FCC CLASS II PERMISSIVE CHANGE REQUEST LETTER

RE: FCC Permissive II Change Request for Company: Outform Ltd.

FCC ID: 2AC8G-UITAS

Adapter

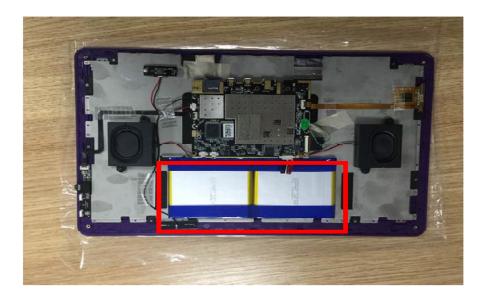
A.The adapter has changed from DVE Switching adapter (Model:DSA-20PFE-05 FUS 050300,Input: AC 100~240V,0.7A, Output:5V/3V) to MASS AC adapter (Model: NBS18C050250VU, Input: AC 100~240V,0.6A Output:5V/2.5V) .

Battery

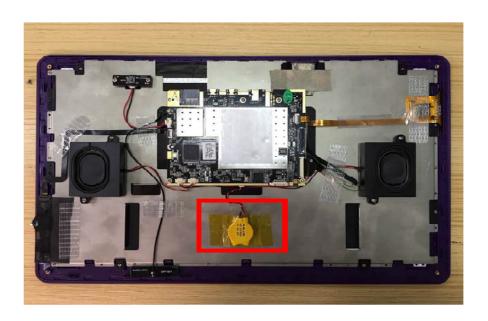
B: The battery has changed from rechargeable Li-lion battery to RTC battery(CR2032).
